Title: Advisory Committee on Reactor Safeguards
Reliability & Probabilistic Risk Assessment
Subcommittee Meeting

Date: Thursday, February 19, 2004

NEI DRAFT 50.69 CATEGORIZATION PROCESS

NEI 00-04 CATEGORIZATION PROCESS

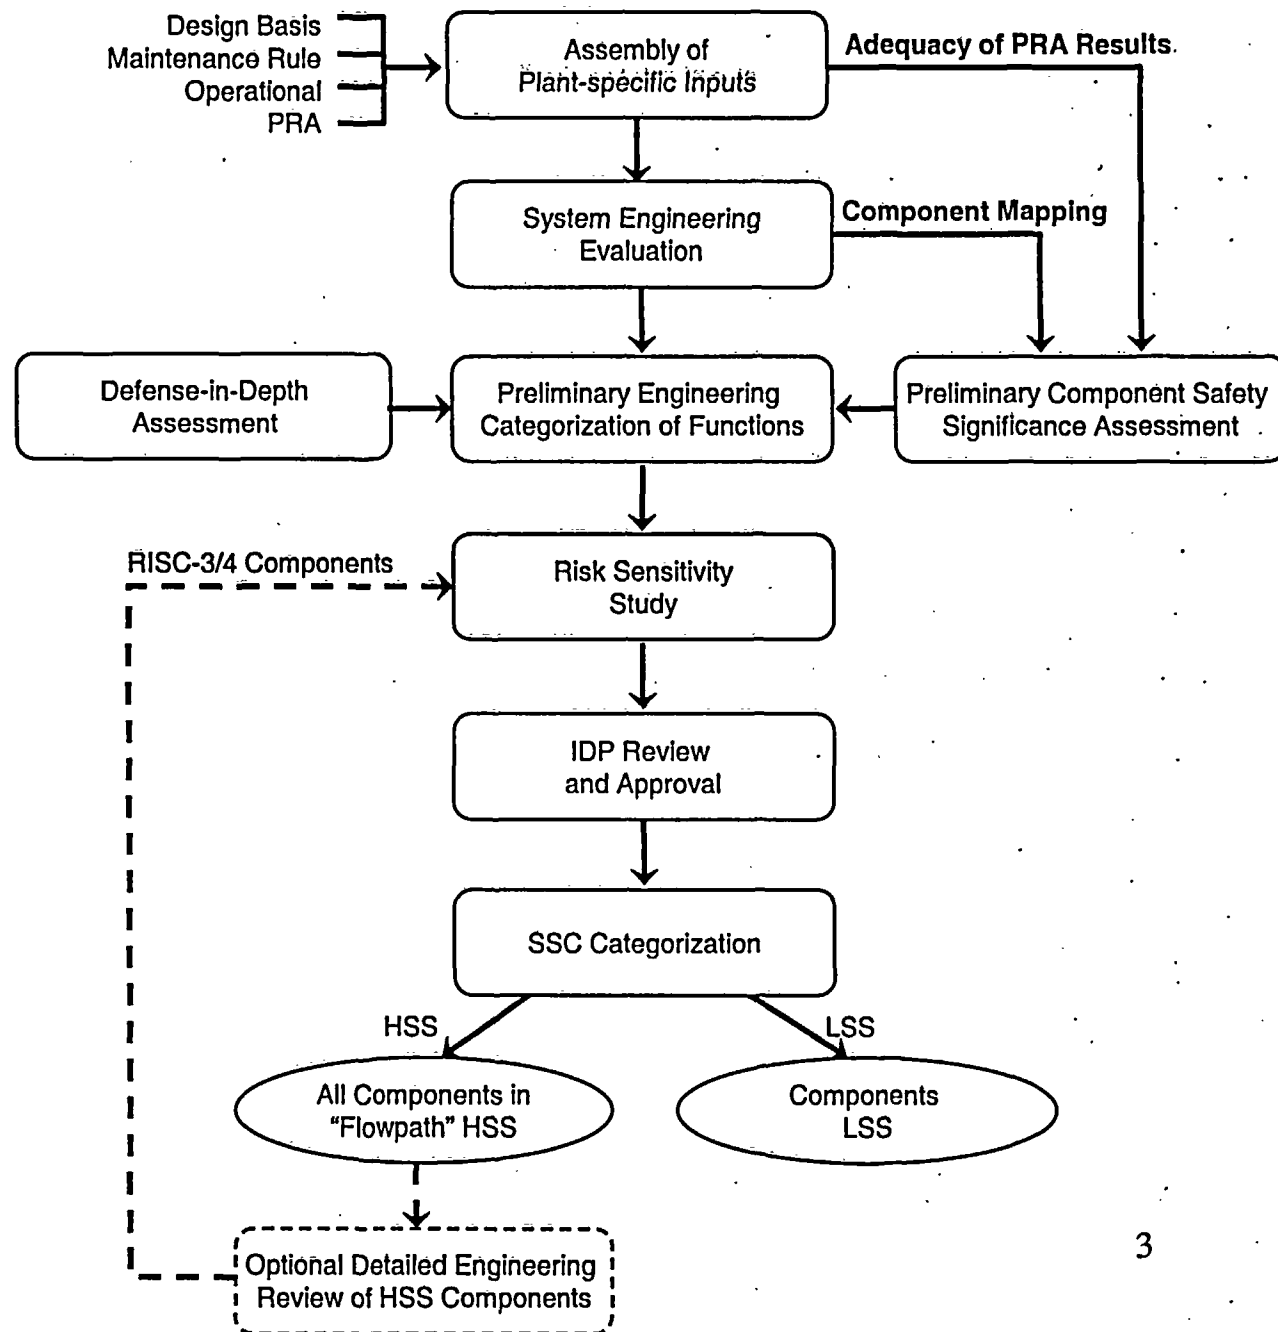
8 CHAIRMAN APOSTOLAKIS: But it seems to
9 me that this diagram can play a very important role
10 in showing what follows in the document. And making
11 sure that -- I mean, it's not a major change of
12 distinguishing between what you do to PRA components
13 SSCs and non-PRA and having the arrows, you know,
14 separate and then meet again somewhere. That would
15 go a long way towards making the diagram much
16 clearer in my view.

3 CHAIRMAN APOSTOLAKIS: I understand
4 that. That it is clear -- I mean the ones that are
5 in the PRA you use importance measures, you do
6 sensitivity studies and so on, for the others you
7 don't. And I don't see how the diagram didn't show
8 it.

5 CHAIRMAN APOSTOLAKIS: Another point
6 here is that I think, and I will raise the issue
7 later, but why this diagram is important, I think
8 that the IDP review and approval should be different
9 for components that are in the PRA and for those
10 that are not. And the staff also has made some
11 comments in their document. And I think we should
12 show that clearly here. And I will raise the issue
13 later again, because I don't want you to spend two
14 hours on the third slide.

24 MR. SHACK: Let me just add one more
25 quibble with this figure while we're at it.

13 CHAIRMAN APOSTOLAKIS: But my point,
14 Tony, is that this chart and the preceding one are
15 sending messages that are very important, in my view
16 anyway. I mean, the Committee eventually will have
17 to discuss these things. And I think you have to
18 show explicitly that you follow one particular path
19 if you have a PRA and another path if you don't.

19 CHAIRMAN APOSTOLAKIS: But that's
20 exactly why I wanted slides three and four to show
21 explicitly two different parts. PRA/non-PRA or
22 outside the scope of PRA. Because they can still be
23 internal events but you worry about late containment
24 failure, for example. And show explicitly what the
25 steps are. And then I think Steve's concern will be

17 CHAIRMAN APOSTOLAKIS: That's why I
18 still think that that the diagram should be revised
19 to show.

OVERVIEW OF CATEGORIZATION APPROACH

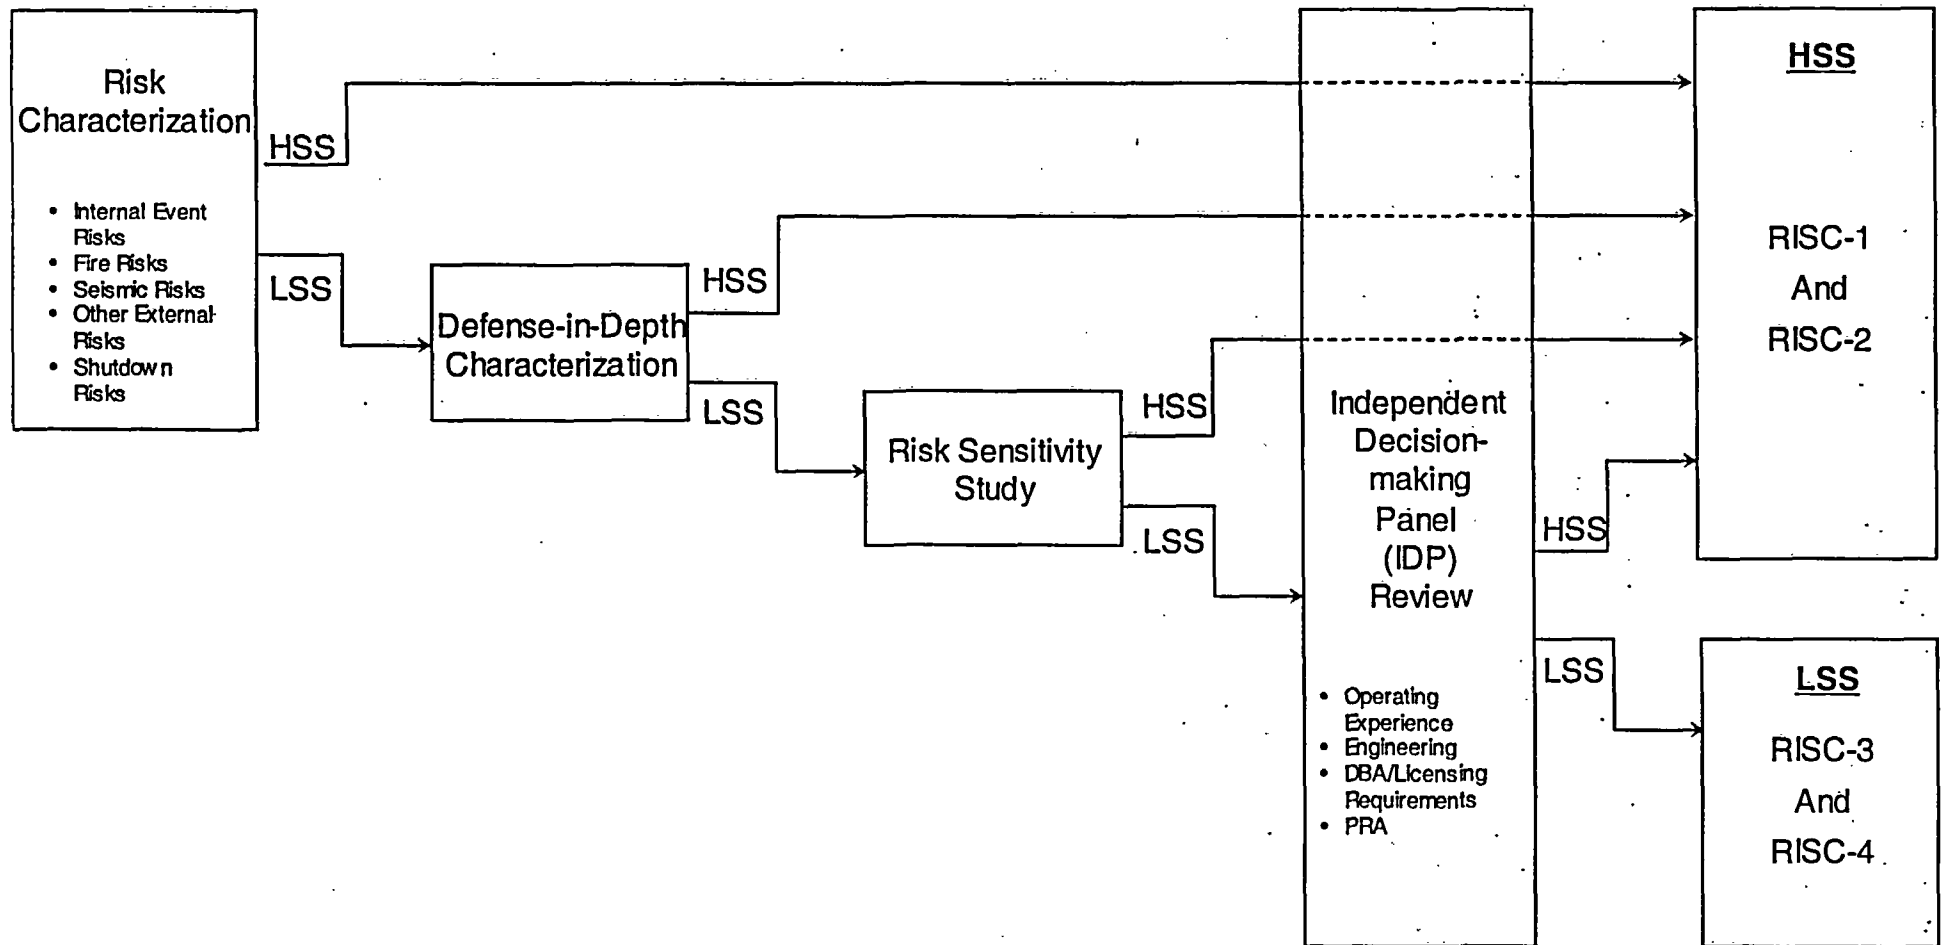
6 So I think that's an important
7 statement. And you can make that explicit here by
8 showing one part with PRA and one part without the
9 PRA. That will also clarify something else. I
10 don't think that the defense-in-depth
11 characterization should be very detailed when you
12 have a PRA. Because the PRA include -- the
13 importance measures do reflect in that. You may
14 want to have a task line there that the IDP looks at
15 it quickly. But the defense-in-depth
16 characterization is much more important when you
17 don't have the PRA. In fact, you and the staff
18 disagree, as we will see later, because the staff
19 has a whole list of questions which really refer to
20 the cornerstones of the ROP and they consider those
21 questions are part of the defense-in-depth
22 evaluation. But when you have a PRA, I don't see
23 why you should go through that because it's already
24 in the importance measures.

21 CHAIRMAN APOSTOLAKIS: For the SSCs for
22 which we have a PRA and we worry about CDF and LERF,
23 there is no reason to go through a detailed
24 difference in that characterization. Now if you
25 want to change that and say but CDF and LERF is not

10 One is I don't really show to the
11 licensees that what the staff says here, that the
12 degree of relief can be expected to be commiserate
13 with the assurance provided. And if you do a good
14 job on the PRA, you're providing more assurance. And
15 second, the IDP will have to do work that is really
16 unnecessary.
